Office Action Summary

10/666,478

SCHMID ET AL.

DETAILED ACTION

FIG. 1B

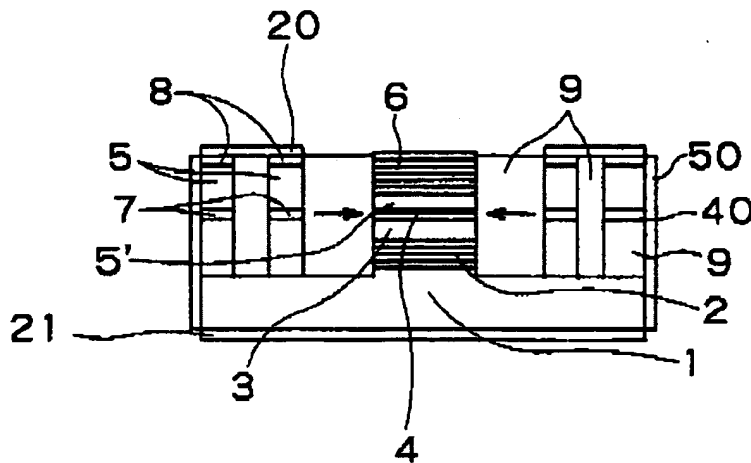
With respect to claim 1, Kinoshita discloses in Fig. 1B a semiconductor laser apparatus having a vertical emitter (1-6) and having at least one pump laser (on the sides) for optically pumping the vertical emitter with the vertical emitter and the pump laser being monolithically integrated. It is inherent that a radiation emitting zone of the pump laser produces less heat /lower temperature than that of the vertical emitter because the vertical emitter provide more powerful laser beam than that of the pump laser.

With respect to claim 2, Kinoshita discloses both pump laser and vertical emitter are grown on a common substrate 1.

With respect to claims 3, Kinoshita discloses the pump laser and the vertical emitter being mounted on a common mount 21 which could be a heat sink.

With respect to claims 4, since the distances between the mount to both active layers of the pump laser and vertical emitter are the same, the thermal resistances depend on the material between the active layers and the common mount. In this case, the material between the vertical emitter includes Bragg reflectors 2 and cladding layer 3. The material between the layer 7 and 21 includes insulating material 9 which has thermal resistance less than the Bragg reflectors and cladding.

With respect to claims 6 and 7, Kinoshita discloses the one or two or more mirror layers 2 are arranged between radiation-emitting zone (upward) and the mount 21 wherein the mirror layers are Bragg mirror.

With respect to claim 8, Kinoshita discloses pump laser has an active layer 7, comprising active zone and the vertical emitter has an active layer 4 comprising its active zone with active layer of the pump laser and active layer of the vertical emitter having the same structure as shown in Fig. 1B.

With respect to claims 10 and 15, Kinoshita discloses the active layers of both pump laser and vertical emitter are formed jointly.

With respect to claims 11 and 16, Kinoshita discloses the radiation-emitting zone (as shown by the arrows) which is perpendicular to the direction of the main emission of the vertical emitter (for this case, it is upward direction).

With respect to claims 12 and 17, since the pump laser is formed on the edge and produces laser from its edge (shown by arrows), it is formed as an edge emitter.
